RE: PLUS review 2014-04-03,
Cadbury at Lewes Expansion
Tax Parcel Number: 3-35-8.00-37.01 (Part of)

On behalf of our client Cadbury at Lewes, Inc., are pleased to submit a response to the PLUS comments received on May 21, 2014 for the proposed expansion of Cadbury at Lewes.

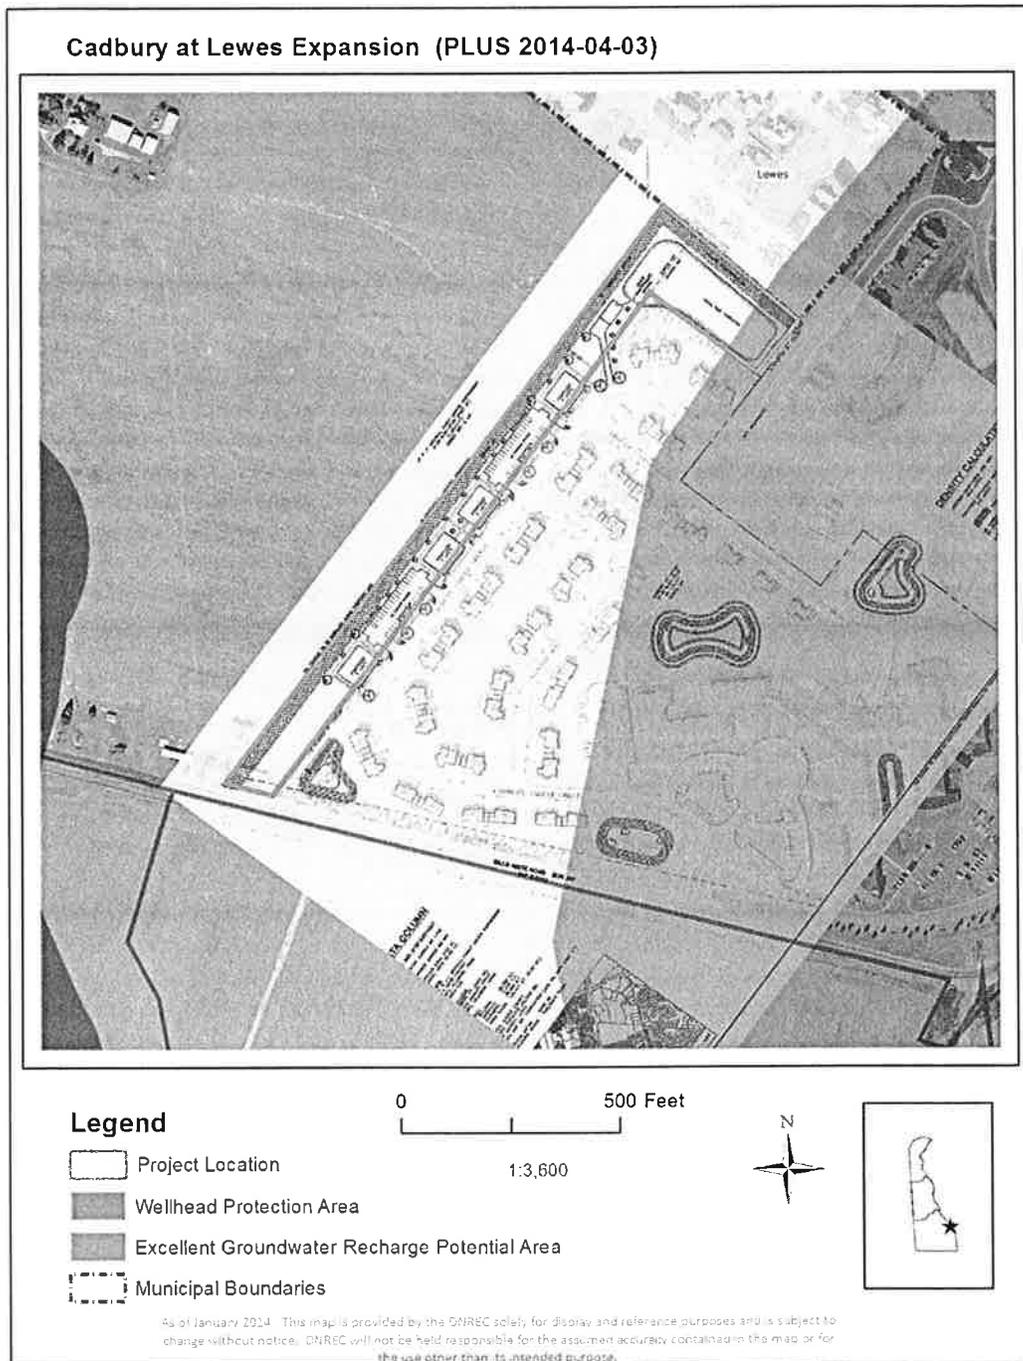
- The DNREC Water Supply Section, Groundwater Protection Branch (GPB) has determined that a portion of the project site falls within an excellent ground-water recharge potential area for Sussex County (see attached map).

Excellent Ground-Water Recharge Areas are those areas mapped by the Delaware Geological Survey where the first 20 feet of subsurface soils and geologic materials are exceptionally sandy. These soils are able to transmit water very quickly from the land surface to the water table. This map category (excellent) is an indicator of how fast contaminants will move and how much water may become contaminated (Andres, 2004). Land use activities or impervious cover on areas of excellent ground-water recharge potential may adversely affect ground water in these areas.

- The site plan shows a wet pond for the management of stormwater. Wet ponds intersect the water table and have the potential to affect the water quality of the aquifer. Some research suggests that pollutant removal is reduced when ground water contributes substantially to the pool volume (Schueler, 1997). Wet ponds as a BMP utilize a settling pond to remove particulates. This type of BMP reduces nutrients by the biological activity of alga. While these systems address the particulate and nutrient components of stormwater runoff, they do not address pathogens, petroleum hydrocarbons, pesticides, other organic compounds, and other inorganic compounds associated with residential land use (DNREC, 1999). Because this is an area of excellent recharge potential, there exists the potential for these constituents to enter the aquifer and compromise water quality.

- DNREC recommends that the wet ponds should be located outside the excellent ground water recharge potential area. In addition, because the excellent ground water recharge area can readily affect the underlying aquifer if contaminants are spilled or discharged across the area, the storage of hazardous substances or wastes should not be allowed within the area unless specific approval is obtained from the relevant state, federal, or local program.

We thank the Section for their comments regarding the excellent recharge area. The type of stormwater system has not been designed and will comply with the Sediment and Stormwater Management Regulations. We will protect the recharge areas to the maximum extent possible and avoid using wet ponds in this area.

Figure 1: NRCS soil survey update mapping in the immediate vicinity of the proposed project

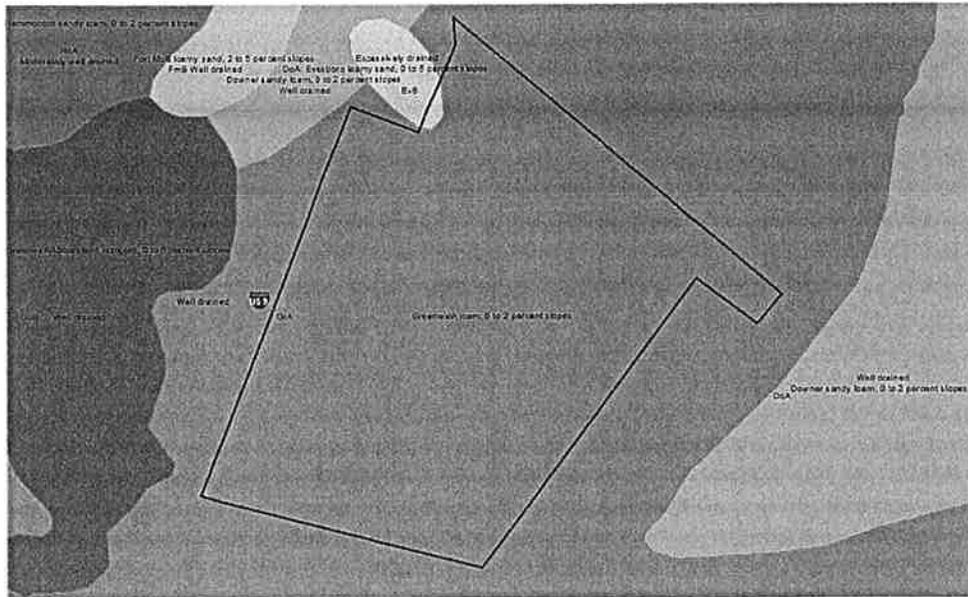
- Based on soils survey mapping update, Greenwich is the predominant soil mapping unit mapped on subject parcel. Greenwich is a well-drained upland soil that, generally, has few limitations for development (Figure 1).

We thank the Department for providing the soils information for this portion of the property. The types of soils are conducive to the type of development proposed.
